Project	IEEE 802.16 Broadband Wireless Access Working Group < http://ieee802.org/16 >	
Title	Revision of Hand-over Mechanism for Mobility Enhancement	
Date Submitted	2003-09-06	
Source(s)	Phillip Barber Broadband Mobile Technologies, Inc. 8302 Sebastian Inlet Frisco, Tx 75035	Voice: +1 (972) 365-6314 Fax: +1 (925) 396-0269 [mailto:pbarber@BroadbandMobileTech.com]
Re:	<p>Response to IEEE 802.16e-03/18 (Call for Contributions on IEEE 802.16e/07r3)</p> <p>Response to Session 26, Comment 66, ‘Hand-off ad-hoc to generate specific text for pre-registration.’</p> <p>Response to Session 26, Comment 74, ‘Issue call for contributions with regards to mobility agent, role of mobile IP, and applicability of this function to fixed (nomadic) operation, to be coordinated with 802.16d.’</p> <p>Response to Session 26, Comment 100, ‘Decide whether parameters can be changed or not during the re-registration process. If not, delete Connection_Info. If they can, delete the last sentence of the CID_update description.’</p> <p>Response to Session 26, Comment 109, ‘Call for contributions to add specific text defining the interaction of sleep mode and handoff, and what happening during a "drop" scenario’</p

In page 54, Annex D.2, Replace Figure D.5 with:

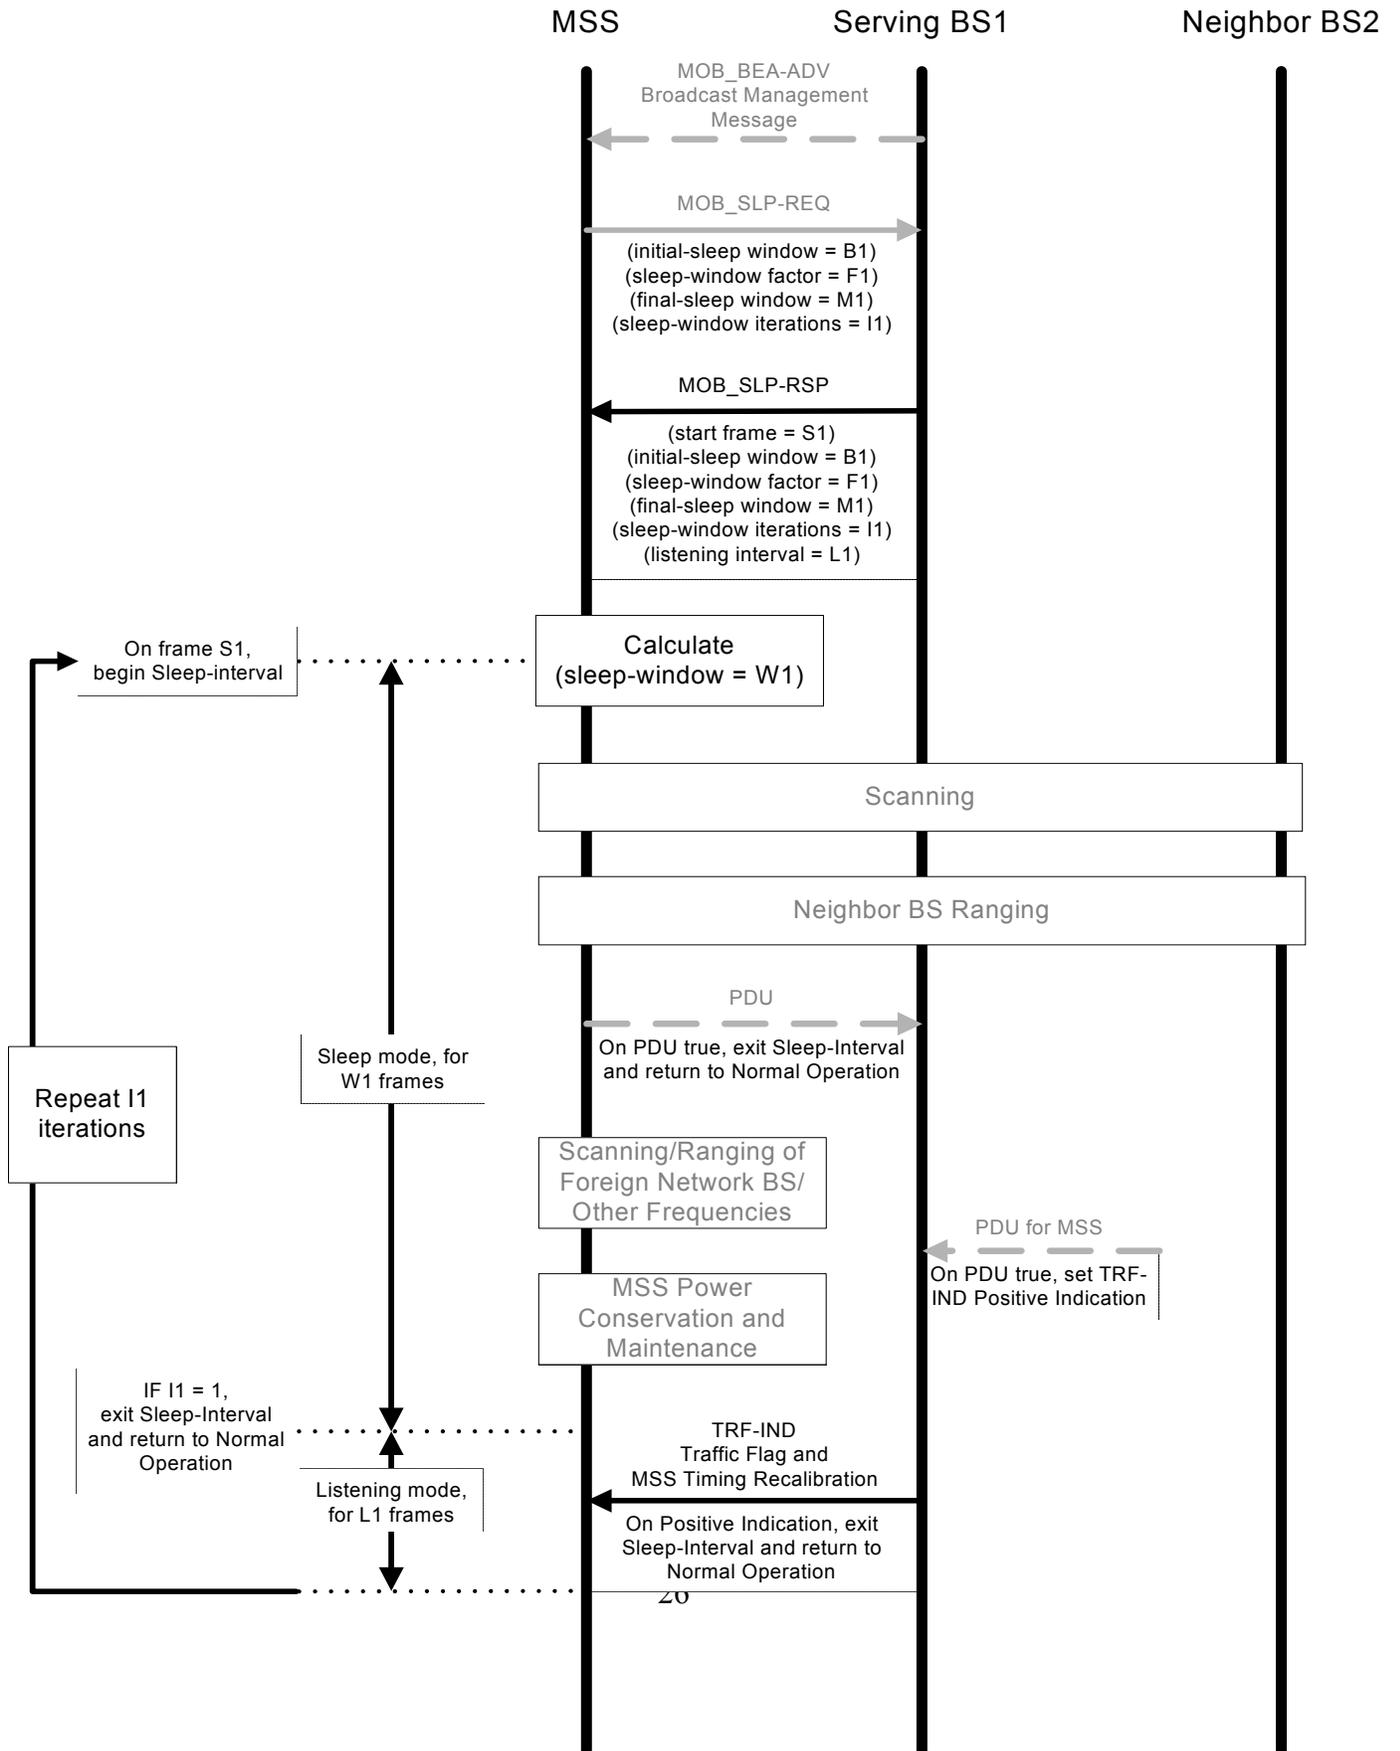
Max_sleep_interval is appropriately constrained by virtue of the max values of its constituent variables.

Max_sleep_interval calculates as 1,038,592 frames under current constraints. This will probably equal to about 5,193 seconds, which should be acceptable. Should this number be seen as too high, it is far preferable to reduce the bit size of some of the constituent variables to reduce Max_sleep_interval.
